Work Order ID 61964

D3687-3 MOUNT

From: David Shepherd [dshepherd@dartaero.com]
Sent: Thursday, September 02, 2010 3:52 PM
To: 'Marc Bellavance'
Cc: 'Jason Murdoch'
Subject: RE: D205-770-011 Replacement Engine Mount Kit
Attachments: image002.jpg

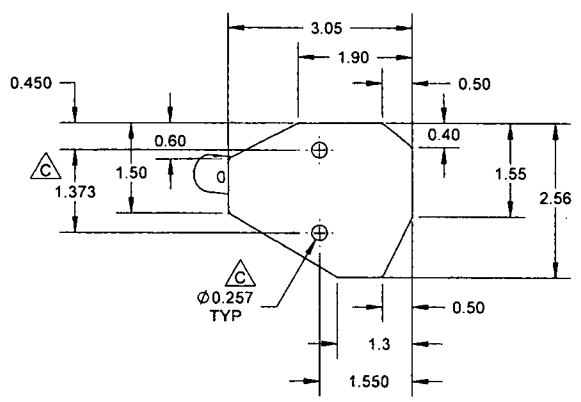
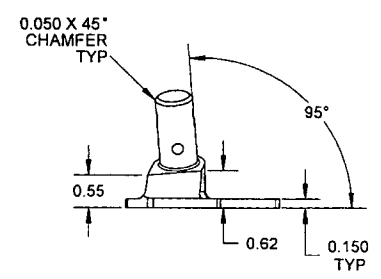
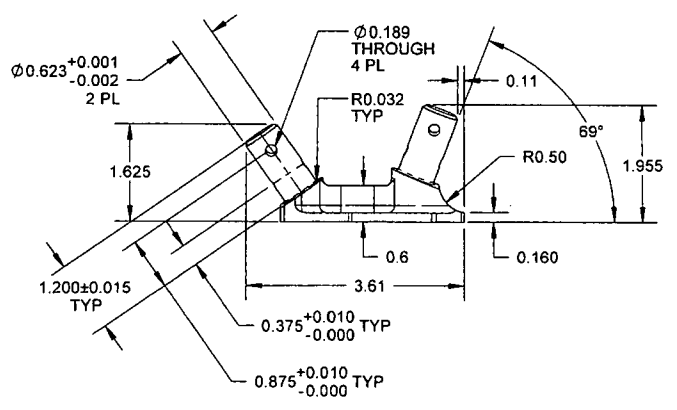
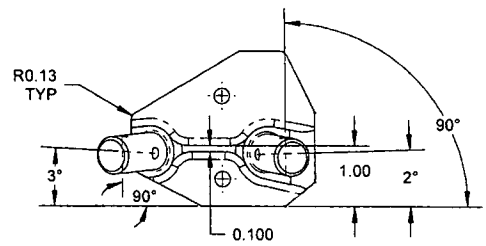
C	0.555 WAS 0.50 (ZN B8-1), 1.373 WAS 1.375 (ZN A8-1, A8-2); ADD 0.620 (ZN B7-1) PER NORM008.084; UPDATE NOTE 8 TO REF QSI (ZN A6-1, B3-2); Ø0.257 WAS Ø0.250 (ZN A6-1, B7-1, B7-2)	RF	09.08.26
B	CHANGE TO 17-4PH H-900 (ZN A6-1 & B3-2); R0.032 WAS R0.015 (ZN C7-1 & C7-2); REFORMATTED TO CURRENT DWG STANDARDS	RF	08.11.24
A	NEW ISSUE	RF	08.03.12
REV.	DESCRIPTION	BY	DATE
DESIGN	RF	DART AEROSPACE LTD	
DRAWN	RF	HAWKESBURY, ONTARIO, CANADA	
CHECKED	<i>9/</i>	DRAWING NO.	REV. 1 OF 1
MFG. APPR.	<i>2/</i>	D3687	SHEET 1 OF 1
APPROVED		TITLE	SCALE
DE APPR.	<i>1/</i>	MOUNT	NT:
DATE	09.08.26	COPYRIGHT © 2008 BY DART AEROSPACE LTD THIS DOCUMENT IS PRIVATE AND CONFIDENTIAL AND IS SUPPLIED ON THE EXPRESS CONDITION THAT IT IS NOT TO BE USED FOR ANY PURPOSE OR FOR REPRODUCTION IN ANY MANNER WITHOUT THE WRITTEN EXPRESS PERMISSION OF DART AEROSPACE LTD.
